UNITED STATES  
NUCLEAR REGULATORY COMMISSION

SUBJECT: NINE MILE POINT UNIT 2 REACTOR OPERATOR AND SENIOR REACTOR  
OPERATOR INITIAL EXAMINATION REPORT NO. 05000410/1999301

### RESOLUTION OF POST-EXAM WRITTEN EXAMINATION COMMENT

#### Question RO 78 and SRO 76

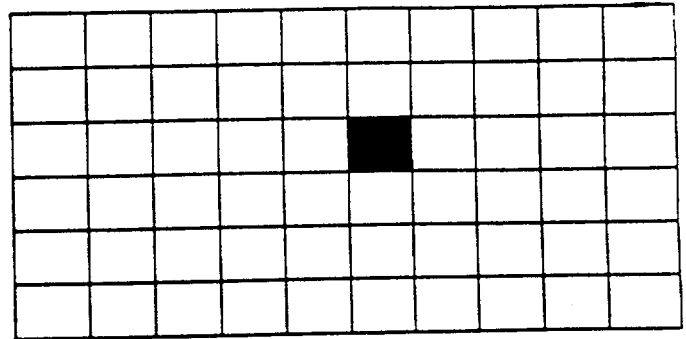
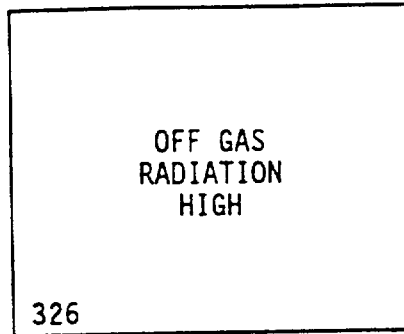
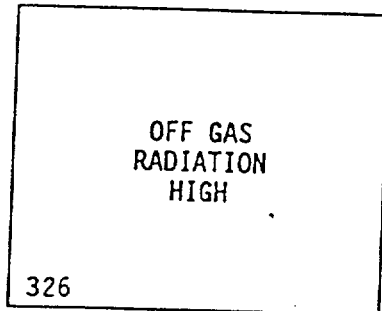
Answer given as "d" but "c" is the correct answer.

Change the correct answer from "d" to "c". The alarm response procedure, which was the basis for the answer was revised after the question was written to indicate that both radiation monitors needed to be at the alert level for Offgas System isolation.

5. Problem Statement (if impacts question grading):  
The question has the wrong answer. The correct answer is "c".
6. Disposition Assigned To: P. BALLARD / E. BOWLER

**Comment:** (enter the comment below)  
*The question has the wrong answer. the correct answer is "c".*

Accept the facility comment and change the correct answer to "c"

**Changes / clarifications made to examination:** (provide a description)  
*Changed the correct answer from "d" to "c".*
